Docket Item #6
BAR CASE # 2007-0002

BAR Meeting
September 5, 2007

ISSUE: Addition and alterations
APPLICANT: Amy & Brien Biondi
LOCATION: 833 South Lee Street
ZONE: RM/Residential

The applicant is requesting approval of a Certificate of Appropriateness for a new third story and a new side addition for the end unit residential rowhouse at 833 South Lee Street.

Figure 2 - Currently proposed east elevation

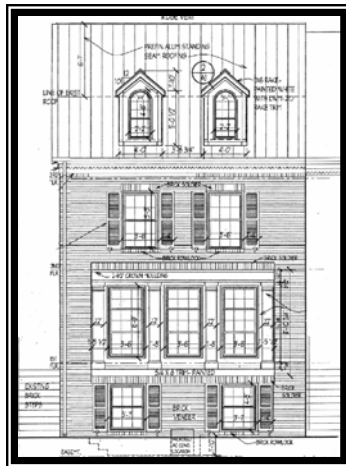
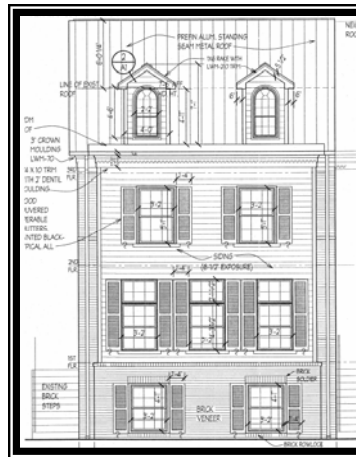
Also proposed is an addition for the east elevation facing South Lee Street. The addition will extend approximately 6'4" from the face of the existing rowhouse and project 2' from the front

façade of the townhouse immediately to the north. The side addition will be indented approximately 1'4" from the corner ends of the original rowhouse so as not to extend across the full width of the house. The basement level will be constructed of brick veneer to match the existing brick. The remainder of the addition will be sheathed in smooth finish Hardiplank with a 6 ½" reveal, and concealed nails. On the ground level there will be two six-over-six windows; on the second level three ganged double-hung six-over-six windows with transoms, and on the third level will be two six-over-six double hung windows. All the windows will be double-glazed wood windows, painted white, with simulated divided lights manufactured by Pella. All wood shutters will be painted black, and operable, with shutter dogs. This addition will have a very slight sloping shed roof, with single ply EPDM membrane roofing, and a 2" dentil molding at the cornice.

Initially, staff was concerned about the addition facing South Lee Street and its impact on the rhythm found in Yates Garden. However, the current proposal of projecting the addition 2' from the adjacent townhouse façade immediately to the north allows for the interplay of recesses and projections to be maintained along South Lee Street. In addition, by indenting or recessing the eastern addition approximately 1'4" on both corners of the townhouse, the size of the addition has been decreased. Furthermore, the choice of siding as the material on this addition helps distinguish the addition from the brick original section of the house, and assists in the reading of the addition as a secondary element to the main section of the house.

Figure 4 - Currently proposed south elevation

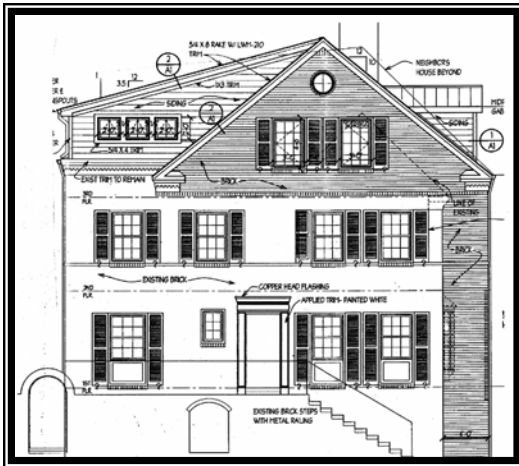
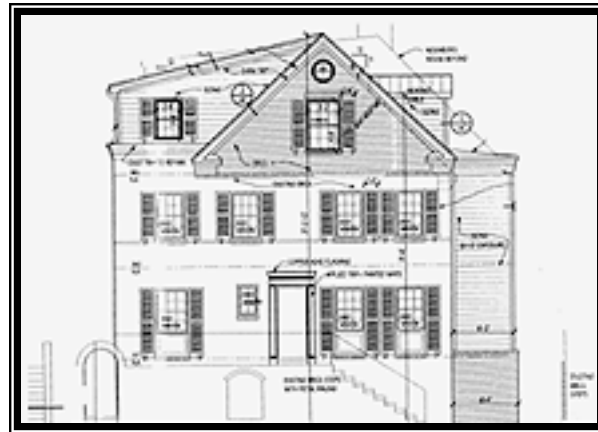
A new third story will be added to the existing house. The south elevation facing Green Street functions as the main entrance to the residence. A new gable third story element will be constructed facing Green Street, with a recessed shed roof intersecting to the western side of the roofline. The roof peak will be raised approximately 6', with a new front roof pitch of 12/11. With the addition, the total height of the house will be 37' 3 1/2" at the peak of the roof line.

The new gable roof element will be clad in brick to match the existing brick, and will have corner trim boards of Hardiplank, painted white, to define the gable. The ends will have a dentil molding cornice that wraps, connecting to the other roof elements. One six-over-six, double-hung, double-glazed wood window with simulated divided lights, by Pella, will be installed in the gable, with a small round accent window above.

The recessed raised roof will slope westward from the peak of the new front gable with a slope of 3.5/12. This southern side facing Green Street will be clad in smooth finish Hardiplank siding, with nails concealed, and painted white. There will be one six-over-six double-hung, double-glazed wood window with simulated divided lights, by Pella installed in this section.

Previously, the Board expressed concerns about the overall design composition of the proposed additions. The applicant has responded to these issues by simplifying the design details on the additions as well as decreasing the amount and types of fenestration proposed. In addressing the design approach of the additions, the applicant reduced the size of the additions so that the additional gross area is well under 50%.

Figure 5 – Previously proposed west elevation

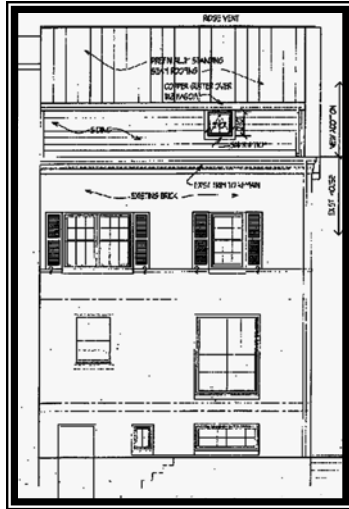
The west face of the new third floor will also be clad in smooth-finish Hardiplank, with concealed nails, and painted white. There will be one six-over-six double-hung, double-glazed wood window, with simulated divided lights, by Pella.
